UNITED STATES PATENT AND TRADEMARK OFFICE

APPLICATION NO.	FILING DATE	FIRST NAMED INVENTOR	ATTORNEY DOCKET NO.	CONFIRMATION NO.
10/522,211	04/04/2006	Zoltan A. Kemeny	D-3184	3664
33197 7590 11/10/2008 STOUT, UXA, BUYAN & MULLINS LLP 4 VENTURE, SUITE 300 IRVINE, CA 92618			EXAMINER VESRA, DINESH K	
			ART UNIT 3633	PAPER NUMBER
			MAIL DATE 11/10/2008	DELIVERY MODE PAPER

Office Action Summary**Application No.**

DETAILED ACTION

Fig. 13

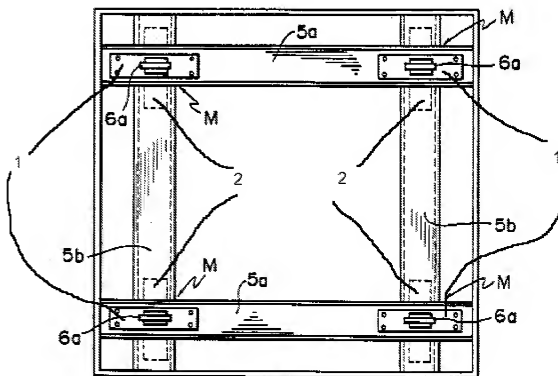
6. **As best understood, claims 3-4 are rejected under 35 U.S.C. 103(a) as being unpatentable over Kemeny in view of Kawai et al. (US patent 5,934,029).** Kemeny discloses the platform as set forth above, but does not disclose wherein said upper plate comprises a plurality of upper plate segments attached to a plurality of corresponding upper connecting members which define said upper plate and further define a plurality of upper interstitial regions; and wherein said lower plate comprises a plurality of lower plate segments attached to a plurality of corresponding lower connecting members which define said lower plate and further define a plurality of lower interstitial regions. Kawai et al. disclose an isolation platform (see Fig. 13 below) wherein said upper plate comprises a plurality of upper plate segments (1) attached to a plurality of corresponding upper connecting members (5a) which define said upper plate and further define a plurality of upper interstitial regions (area between members 5a); and wherein said lower plate comprises a plurality of lower plate segments (2) attached

to a plurality of corresponding lower connecting members (5b) which define said lower plate and further define a plurality of lower interstitial regions (area between members 5b). It would have been obvious to one of ordinary skill in the art at the time the invention was made to provide the isolation platform of Kemeny with this configuration in view of the teachings of Kawai et al. The motivation for doing so would be that using a plurality of plate members connected together would allow for a stronger base for a building or machinery to rest on.
